# Winn Brook Park

## Town of Belmont ADA Transition Plan

August 2021

Institute for Human Centered Design

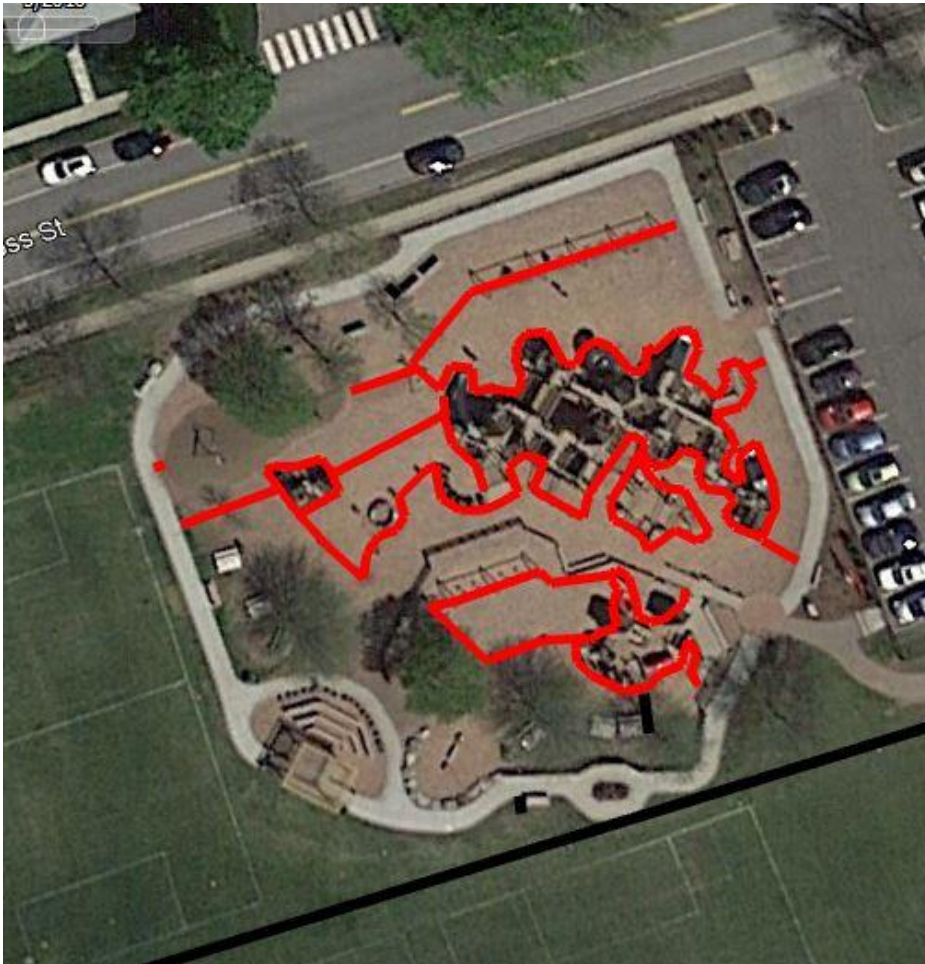
The parking lot lacks one car accessible and one van accessible parking space.

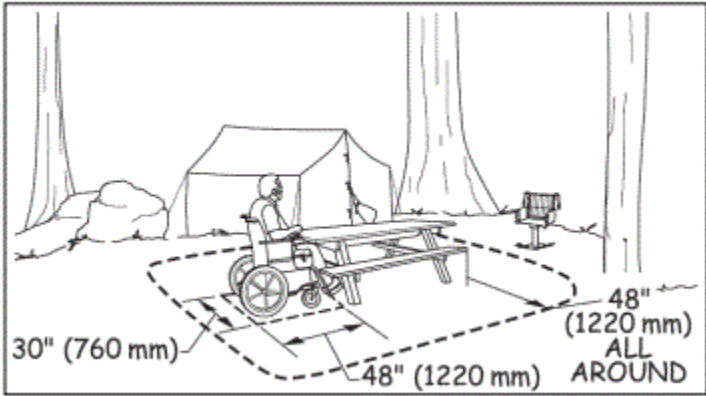
- Lack of a directional sign at the inaccessible entrance to the playground.
- Lack of maneuvering clearance with a slope of 1:50 (2%) max. at the Cross Street entrance to the park.
- Lack of an accessible route to one bench in each area.
- Lack of a wheelchair space in the seating area in front of the stage. See following diagram showing the recommended location of the wheelchair space in purple:

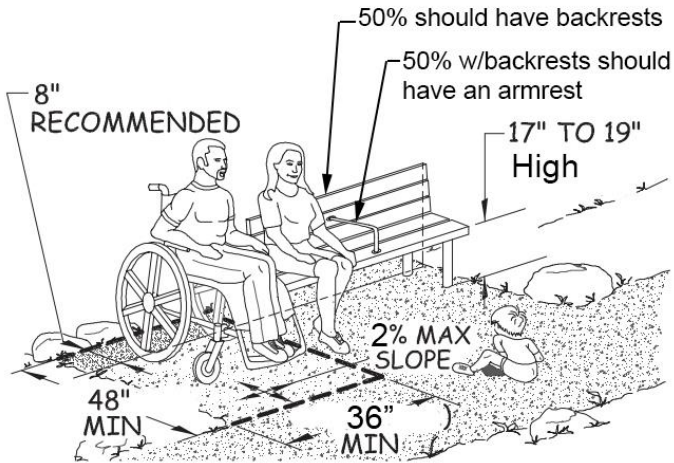
- Recommend providing benches at tennis courts.
- As the rise to the stage is less than 6", handrails are not required, but for greater access consider providing circular handrails located between 34" - 38" high and between 18" - 20" high with 12" extensions at the top and bottom of the ramp run.
- Recommend providing a 48" wide min. stable, firm and slip resistant surface under and around accessible picnic tables. See the following diagram:
